## Firmware 2.06.3 bug list:

## List of bugs/improvement requests

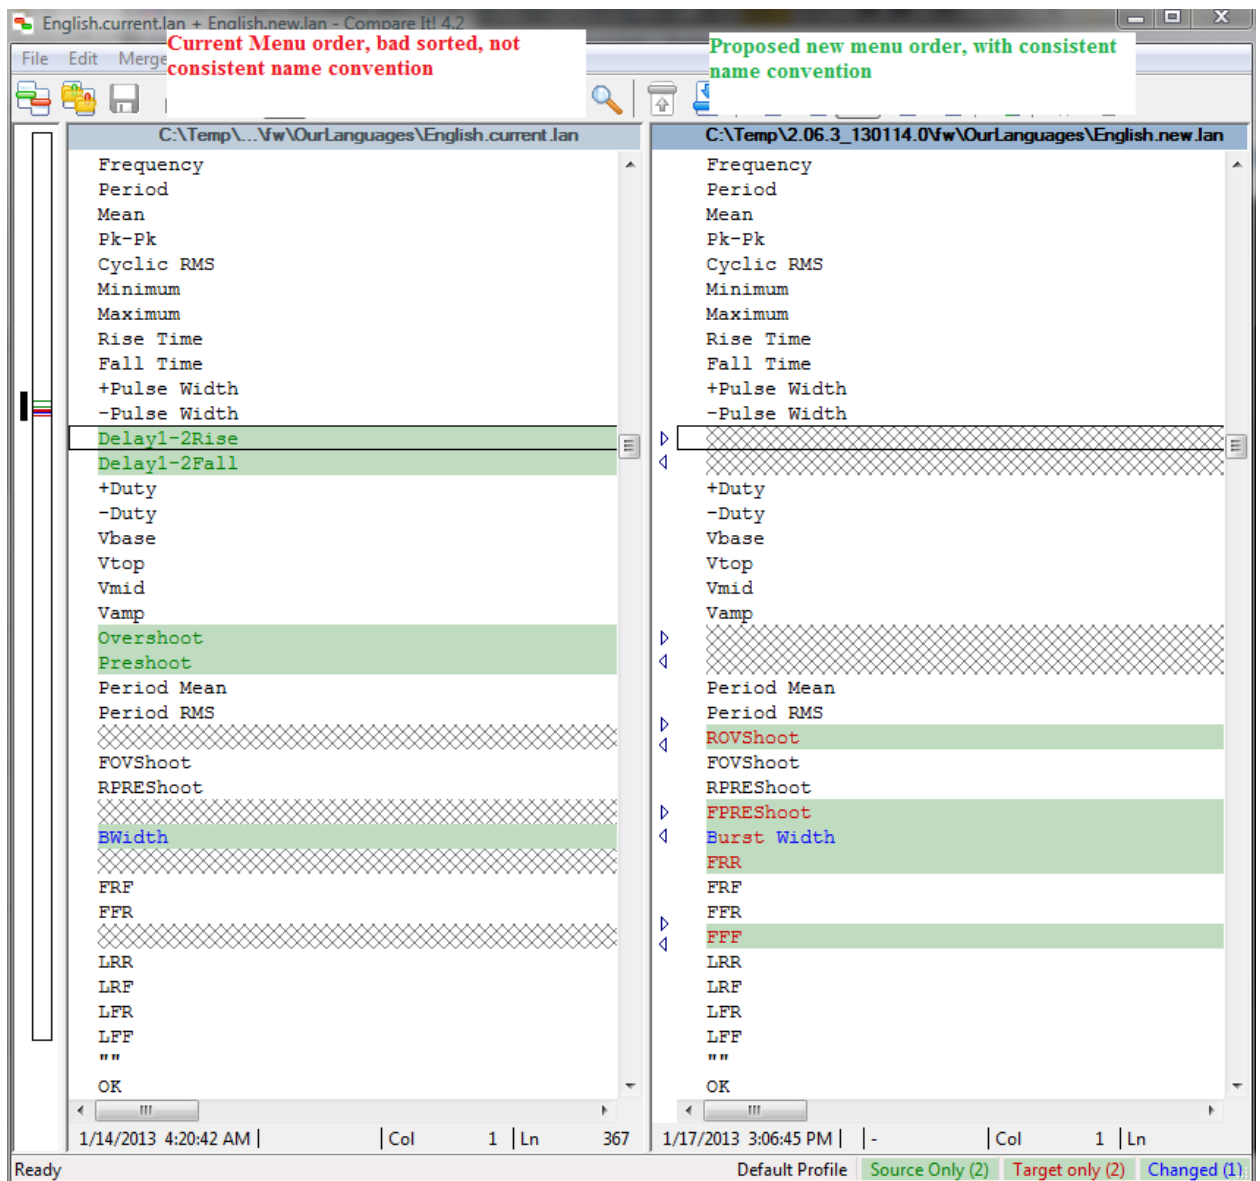
42. Measurement “Delay1-2Rise” and “Delay1-2Fall” displaying too long (wrong) result when the delay is equal zero (no delay):

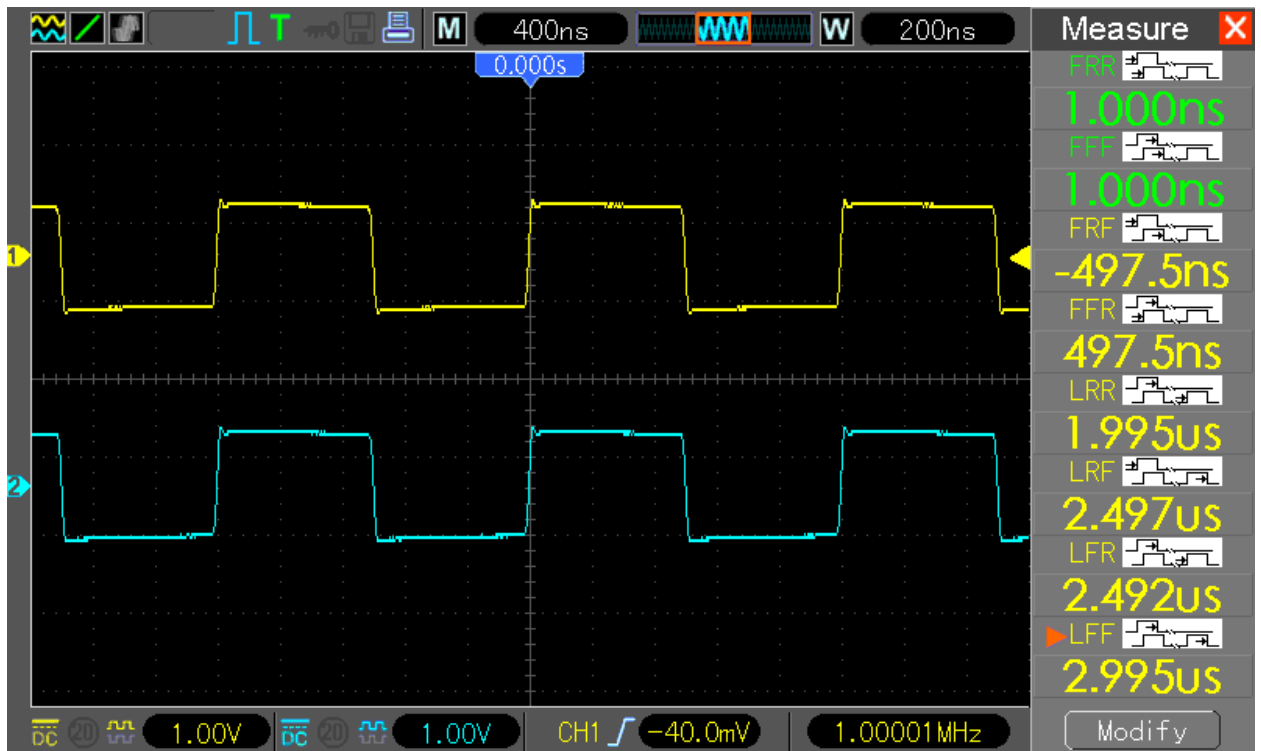
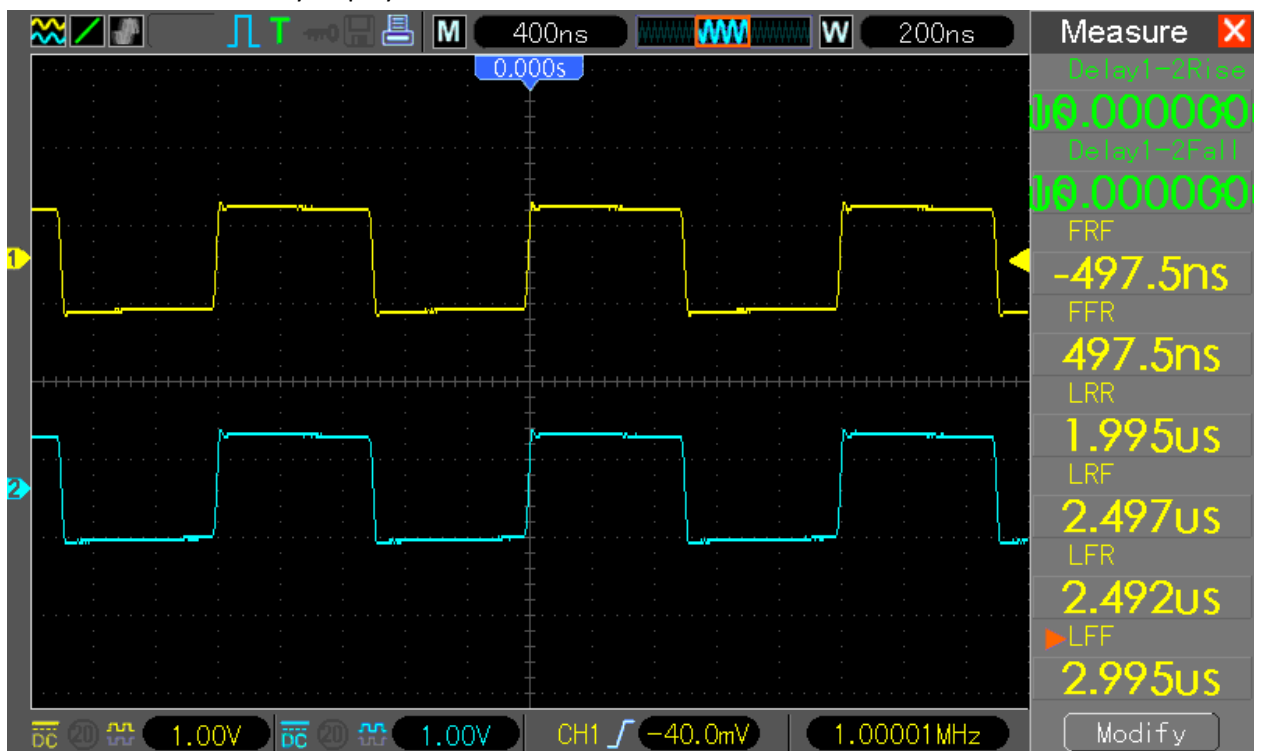
43. The current Measurement menu not consistent (sorting/name convention) and hard readable.  
New proposed sorting and name convention :

additionally a set of icons should be to allow the End-user to quick identify all the new measurements (“LFF,LFR,LRF,LRR,FFF,FFR,FRF,FRR”) without detailed knowledge of the “cryptic” names. I’ve prepared already all necessary icons:

The measure menu can then looks like following picture :

instead of what currently displayed:

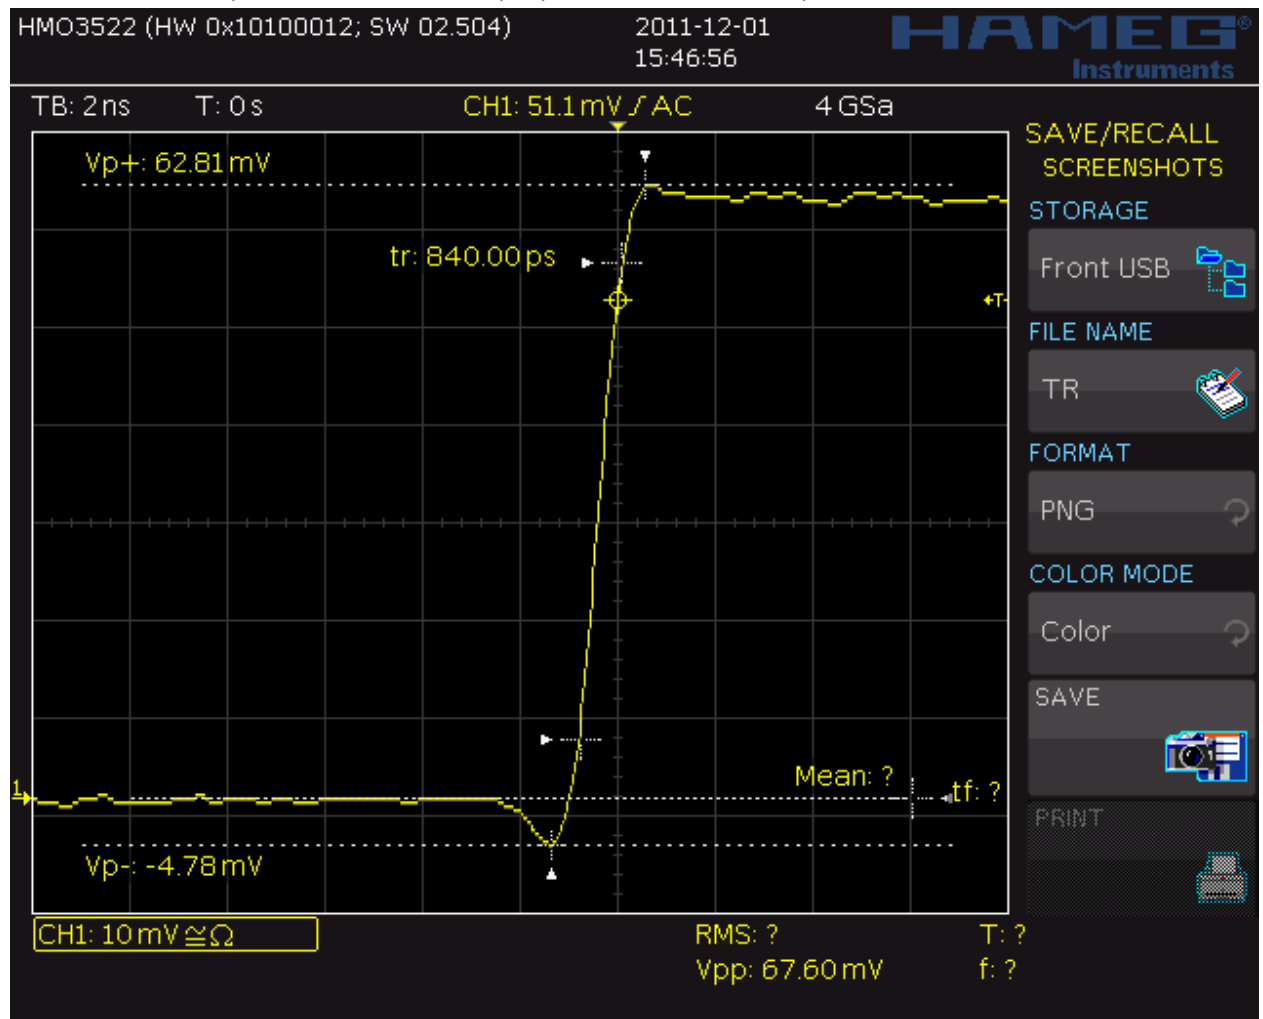
45. **Request** – add shading for pixels on screen. To optimize the view shading for pixels could be added (maybe even as separate Menu, to enable/disable shading)

However this could be improved by changing the **FIRST bottom pixels with shaded** color, like:

which is zoomed part of this Hameg HMO picture, on which line look really sharp (where we

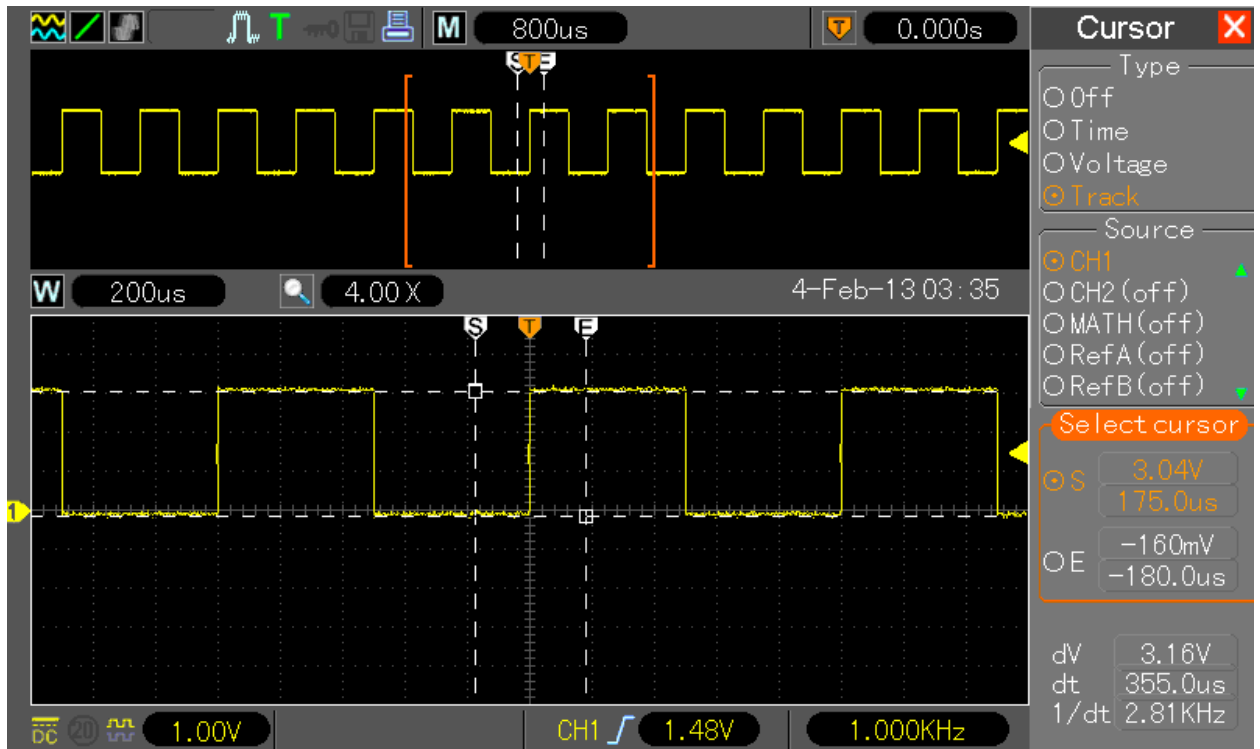
46. Change all non-SI conform values to SI-conform :

unit\_KV is now "KV" but should be "kV"

unit\_KHz is now "KHz" but should be "kHz"

unit\_KS\_S is now "KS/s" but it should be "ks/s"

unit\_krads is now "Krad/s" but it should be "krad/s"

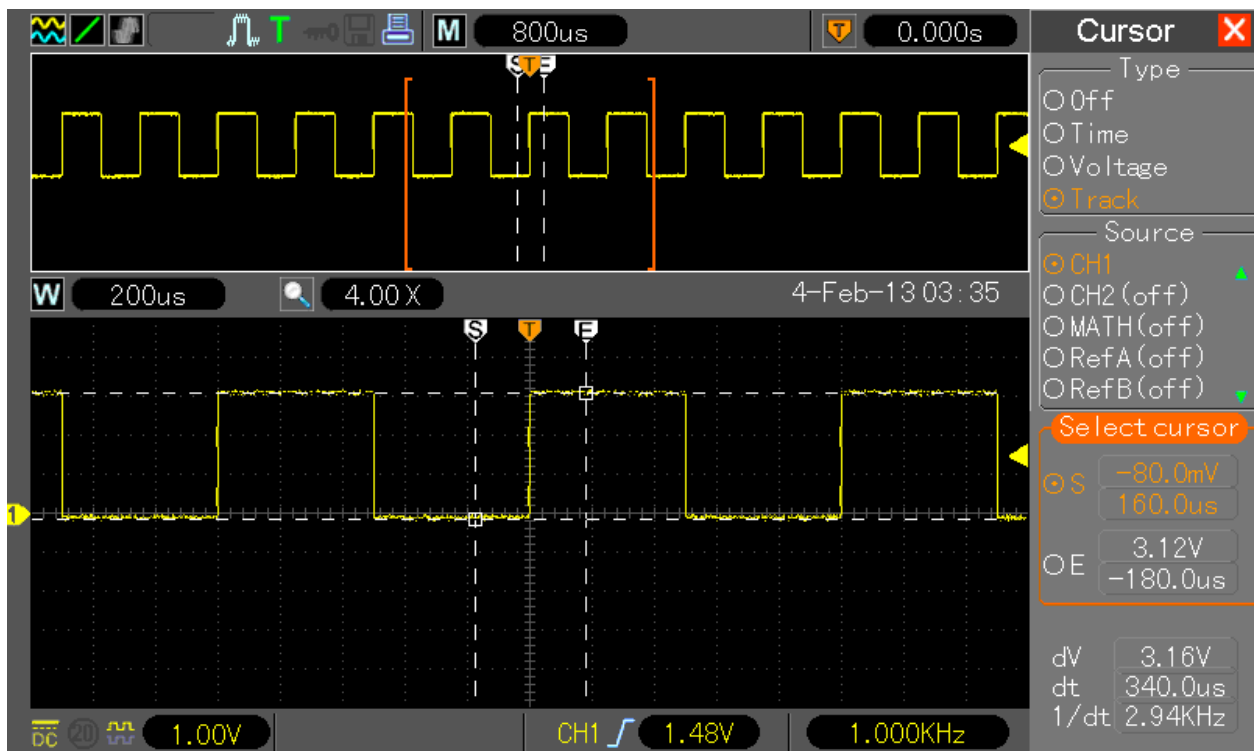
47. Tracking cursor not working when Zoom (W) window focused

When Main Windows selected (M) the tracking cursor however works good:

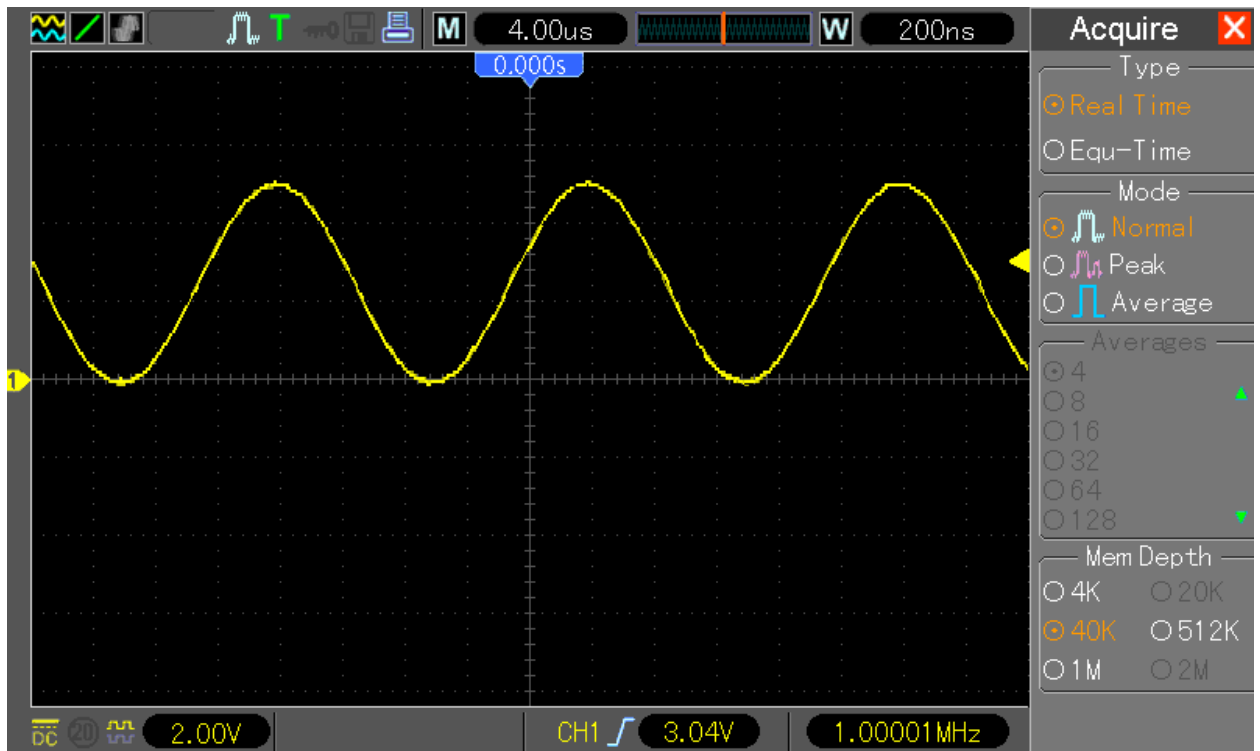
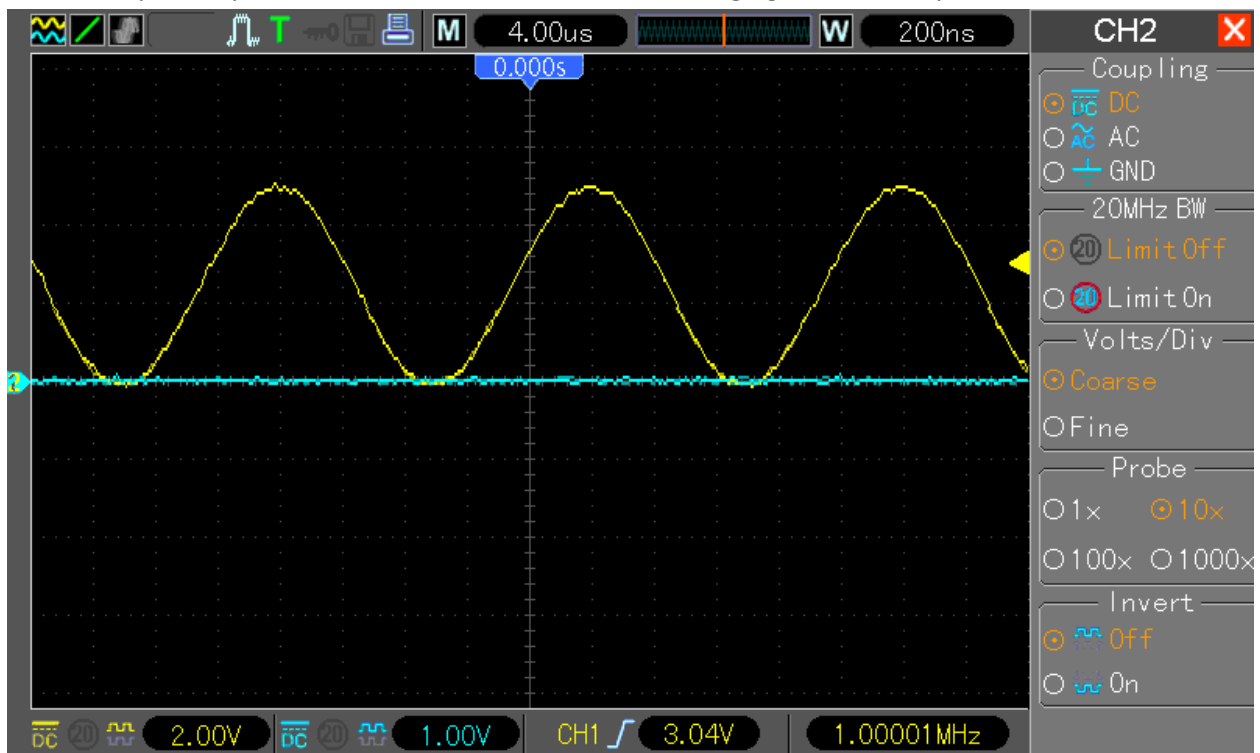
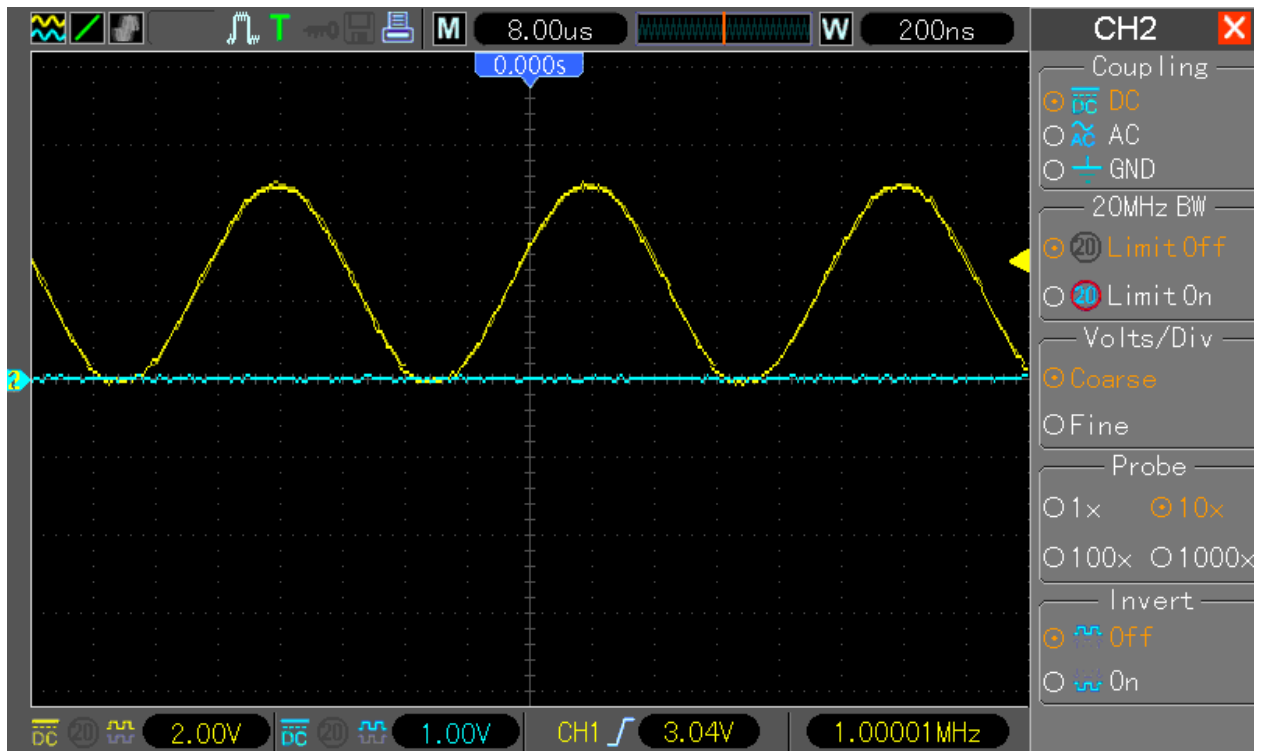
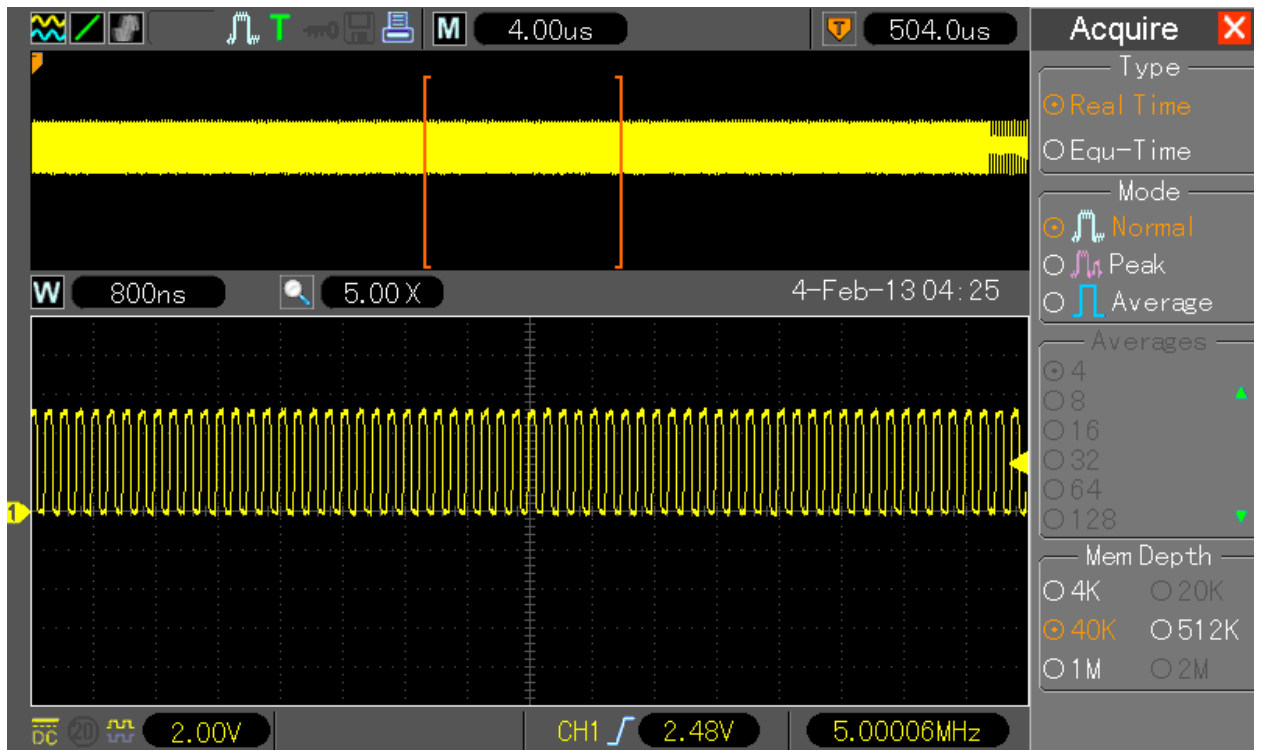
48. When changing memory depth, the MTB is not changing automatically together. Set following on DSO, 4k, 1ch, 200ns/DIV MTB:

change now memory depth to 40k, the MTB is still displaying 200ns/DIV

when you turn now timebase now one position up and down the MTB is displaying proper value, 4us/DIV:

Additionally when you enable now ch2, the value is not changing automatically to 8us/DIV:

you have to turn again timebase knob one up and down position to get display updated to proper value which is in this example 8us/DIV:
